Heater Control Valve: All Technical Service Bulletins

Number: 91-413-1A

Subject: LOW HEAT DELIVERY RELATED DIAGNOSIS REVISED PROCEDURE

Model and Year: 1989-91 CAVALIER

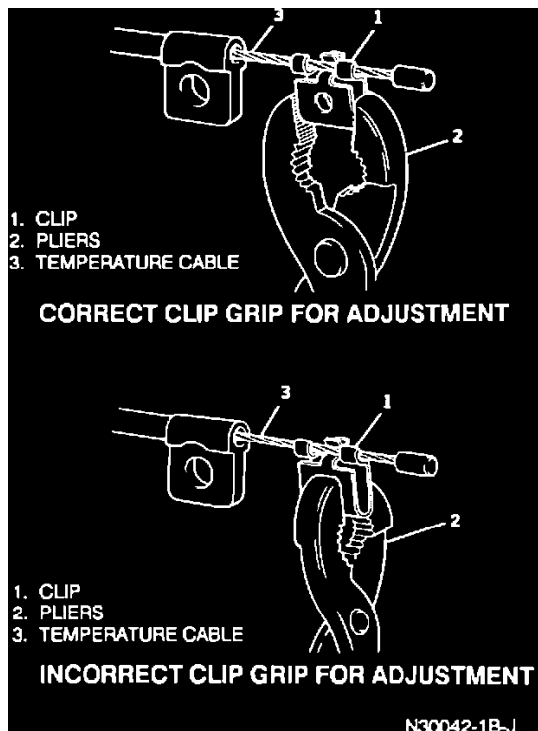
TEMPERATURE CONTROL CABLE ADJUSTMENT PROCEDURE

Condition: 1. "Spring back" off full "hot" temperature control position (or not attaining full "cold" temperature door position).

Condition: 2. "Spring back" off full "cold" temperature control position (or not attaining full "hot" temperature door position).

Cause: The temperature control cable "clip" needs adjustment. Refer to the illustration for correct gripping of the "clip" during adjustment.

Correction
 For Number: 1. Grip "clip" at module end of cable while pulling temperature control lever to "hot" position.

For Number: 2. Grip "clip" at module end of cable while pushing temperature control lever to "cold" position.

NOTICE: FAILURE TO GRIP "CLIP" CORRECTLY WILL DAMAGE ITS ABILITY TO HOLD POSITION ON THE CABLE. THE TEMPERATURE CONTROL CABLE MUST BE REPLACED IF "CLIP" RETENTION FAILS.

Verify correct adjustment after repair by observing for no, or very little, "spring back" of the temperature control lever and listening for temperature door "slam" when the control lever is moved to full hot and cold positions quickly.
